LAND USE APPLICATION COMPLETENESS REVIEW

Second Review Comments

Subject Property: 1105 Front Street NE

Reference Nos.: 24-106451-PLN (Class 3 Site Plan Review, Tentative Subdivision Plan, Class 1 & 2 Adjustment, Class 2 Driveway Approach Permit)

PRELIMINARY SITE PLAN
THE CANNERY
FUND
SALEM, OREGON

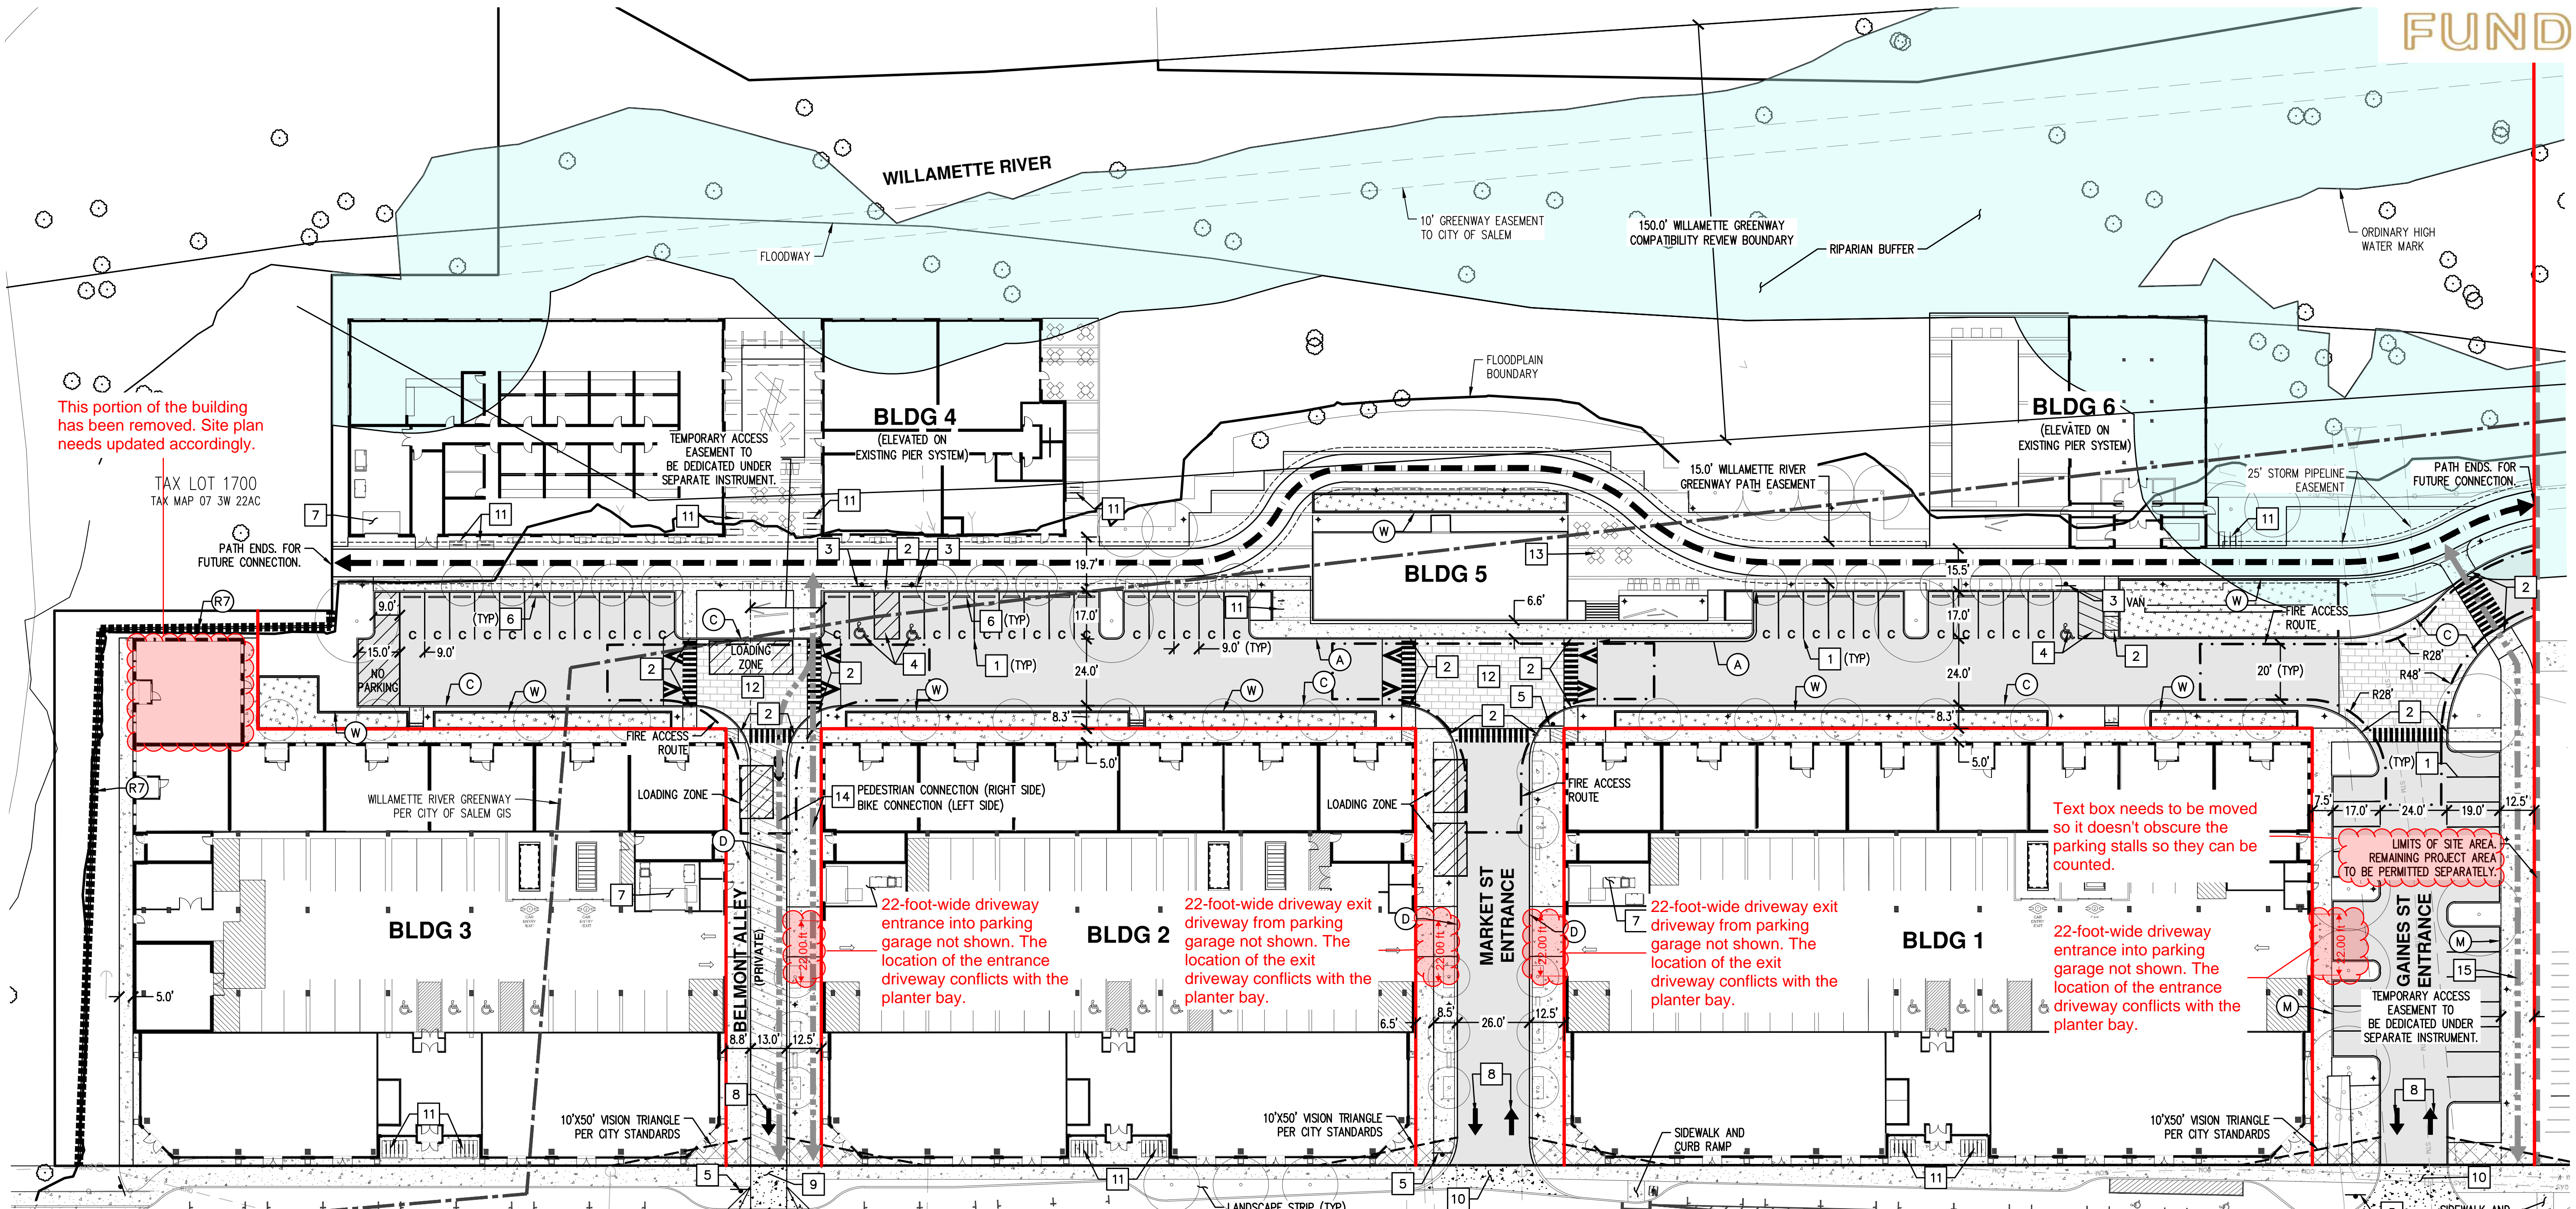
This portion of the building has been removed. Site plan needs updated accordingly.

Text box needs to be moved so it doesn't obscure the parking stalls so they can be counted.

22-foot-wide driveway entrance into parking garage not shown. The location of the entrance driveway conflicts with the planter bay.

22-foot-wide driveway exit driveway from parking garage not shown. The location of the exit driveway conflicts with the planter bay.

22-foot-wide driveway exit driveway from parking garage not shown. The location of the exit driveway conflicts with the planter bay.

22-foot-wide driveway entrance into parking garage not shown. The location of the entrance driveway conflicts with the planter bay.

1 LANDSCAPE LAND USE DIAGRAM

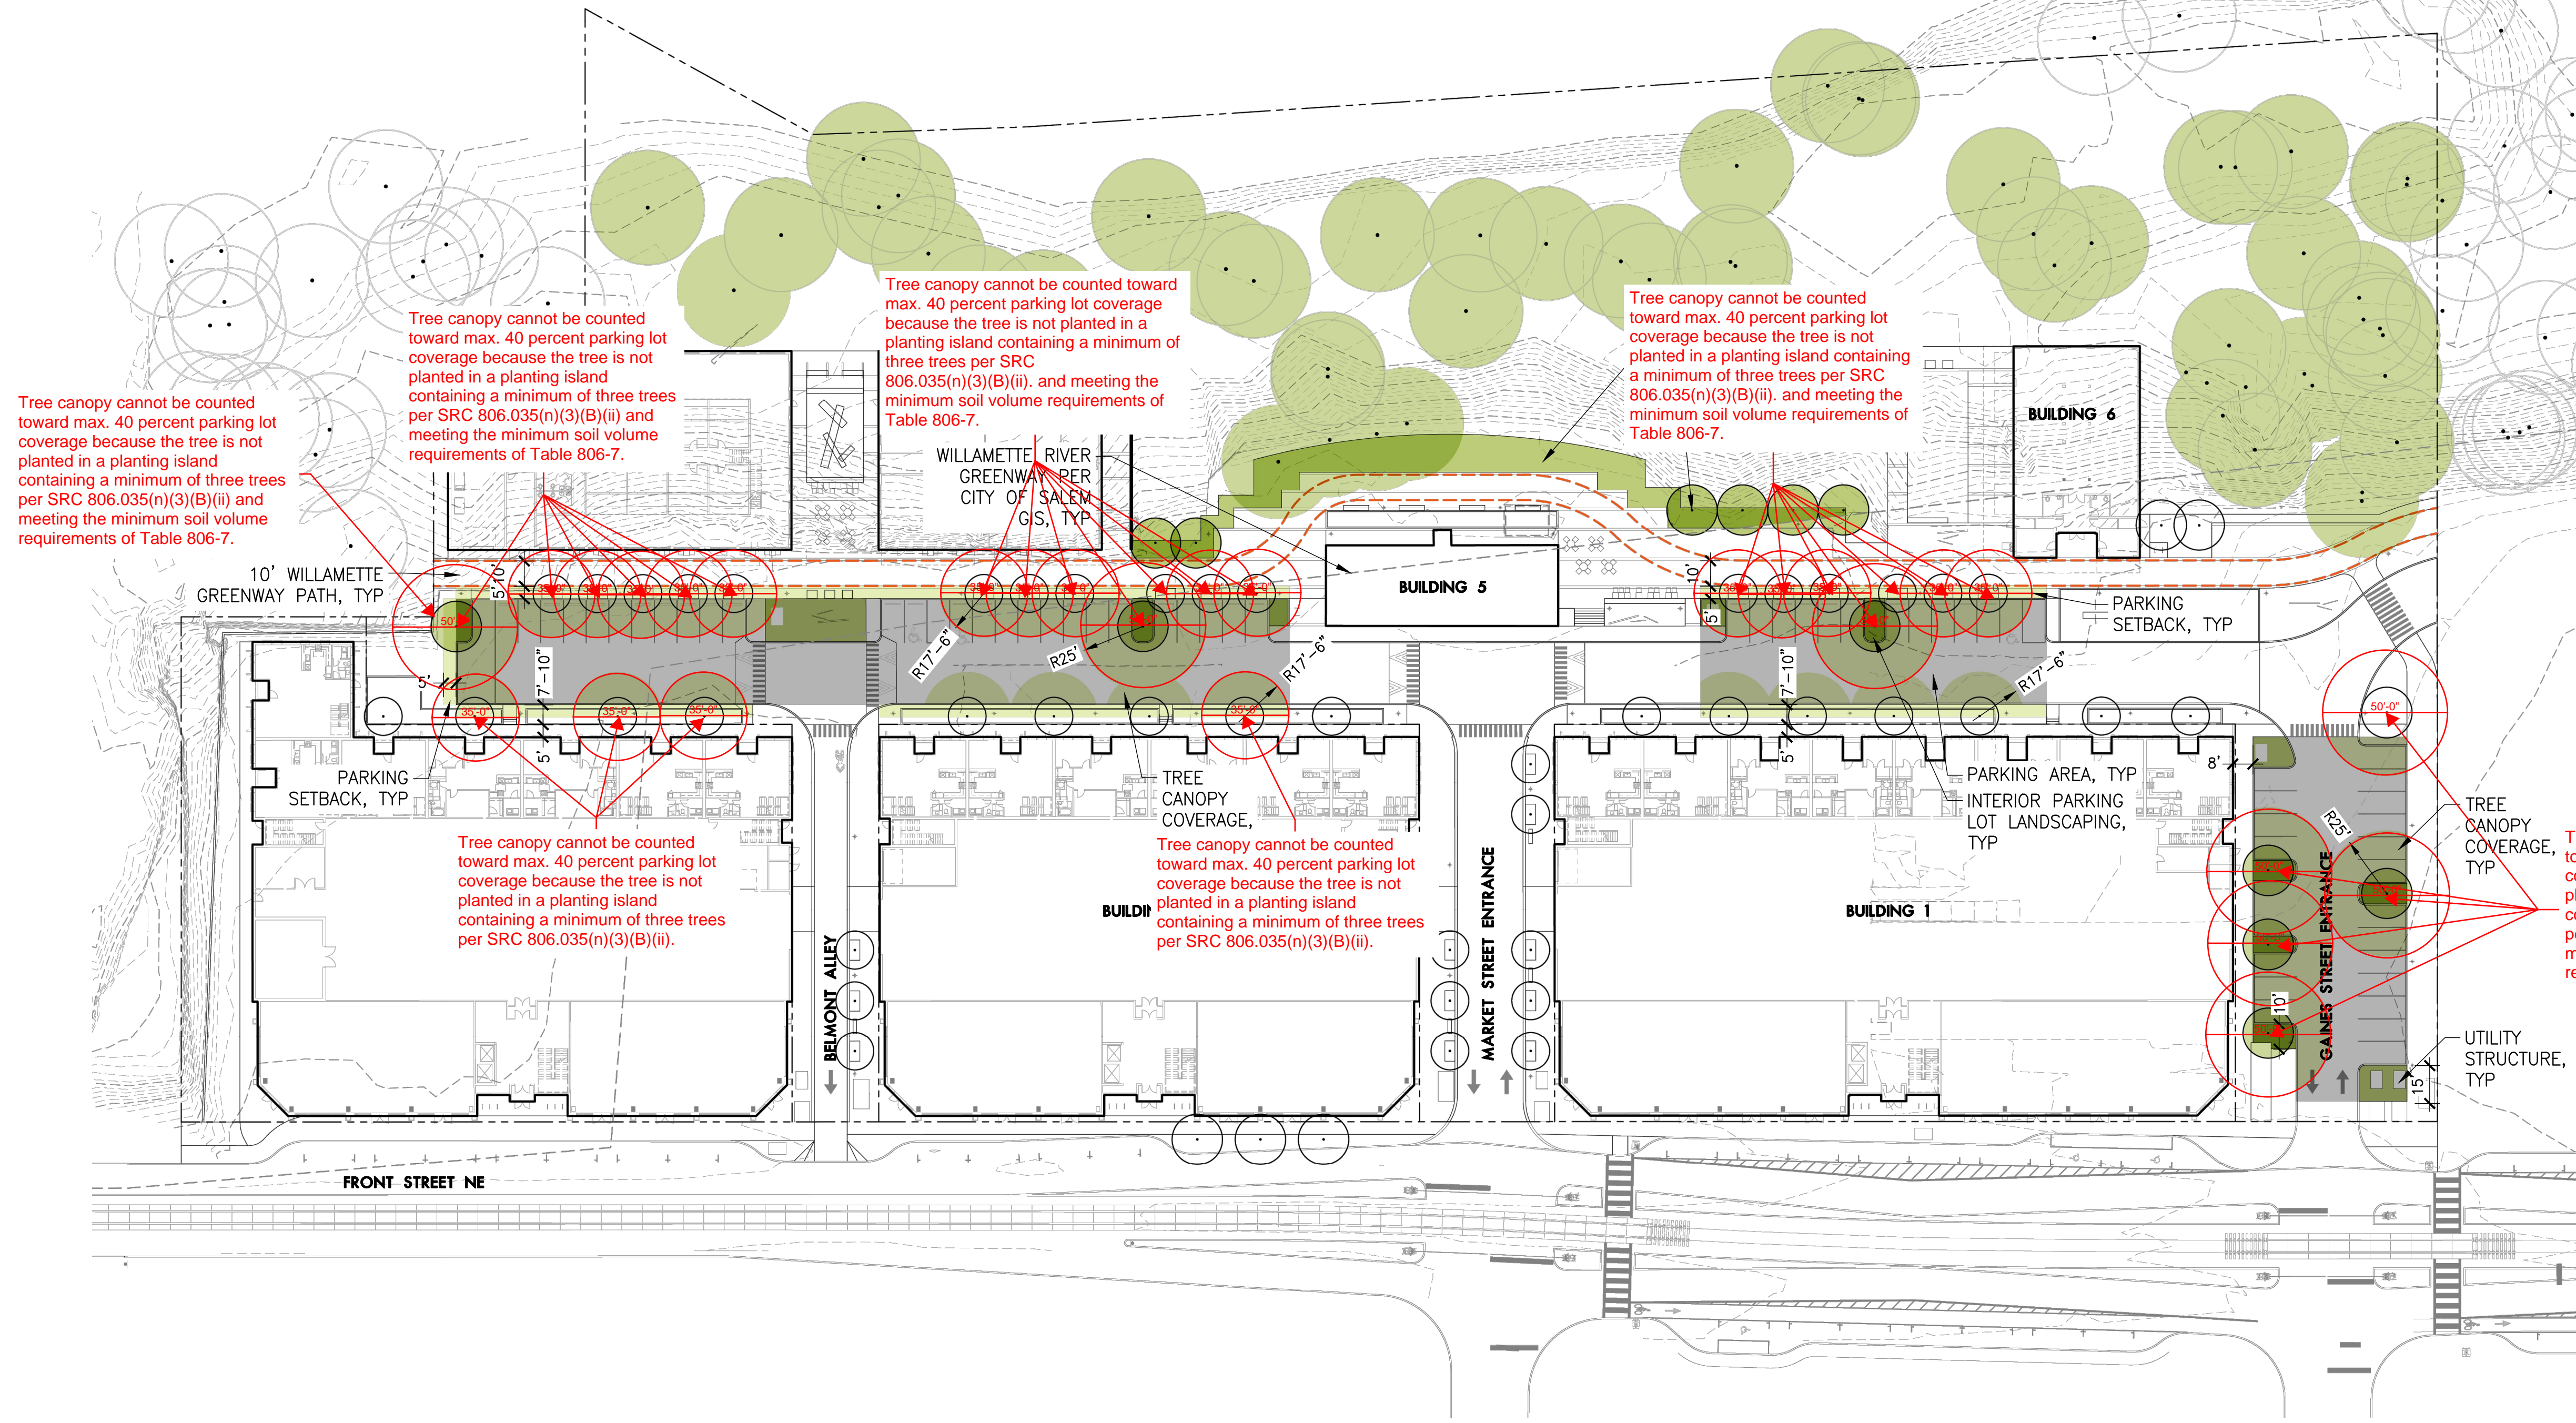
Tree canopy cannot be counted toward max. 40 percent parking lot coverage because the tree is not planted in a planting island containing a minimum of three trees per SRC 806.035(n)(3)(B)(ii) and meeting the minimum soil volume requirements of Table 806-7.

Tree canopy cannot be counted toward max. 40 percent parking lot coverage because the tree is not planted in a planting island containing a minimum of three trees per SRC 806.035(n)(3)(B)(ii) and meeting the minimum soil volume requirements of Table 806-7.

Tree canopy cannot be counted toward max. 40 percent parking lot coverage because the tree is not planted in a planting island containing a minimum of three trees per SRC 806.035(n)(3)(B)(ii) and meeting the minimum soil volume requirements of Table 806-7.

Tree canopy cannot be counted toward max. 40 percent parking lot coverage because the tree is not planted in a planting island containing a minimum of three trees per SRC 806.035(n)(3)(B)(ii) and meeting the minimum soil volume requirements of Table 806-7.

Tree canopy cannot be counted toward max. 40 percent parking lot coverage because the tree is not planted in a planting island containing a minimum of three trees per SRC 806.035(n)(3)(B)(ii).

Tree canopy cannot be counted toward max. 40 percent parking lot coverage because the tree is not planted in a planting island containing a minimum of three trees per SRC 806.035(n)(3)(B)(ii).

Tree canopy cannot be counted toward max. 40 percent parking lot coverage because the tree is not planted in a planting island containing a minimum of three trees per SRC 806.035(n)(3)(B)(ii) and meeting the minimum soil volume requirements of Table 806-7.

Red Alder is not a species of tree identified in the table of approved trees for planting in parking lots to achieve required tree canopy coverage per SRC 806.035(n)(3)(A)(ii). An alternative species can be approved by providing evidence that the proposed species is native, drought resistant, and will provide a tree canopy area equal to that of either a large tree or small tree as specified in TABLE 806-7.

Quaking Aspen is not a species of tree identified in the table of approved trees for planting in parking lots to achieve required tree canopy coverage per SRC 806.035(n)(3)(A)(ii). An alternative species can be approved by providing evidence that the proposed species is native, drought resistant, and will provide a tree canopy area equal to that of either a large tree or small tree as specified in TABLE 806-7.

California Black Oak is not a species of tree identified in the table of approved trees for planting in parking lots to achieve required tree canopy coverage per SRC 806.035(n)(3)(A)(ii). An alternative species can be approved by providing evidence that the proposed species is native, drought resistant, and will provide a tree canopy area equal to that of either a large tree or small tree as specified in TABLE 806-7.
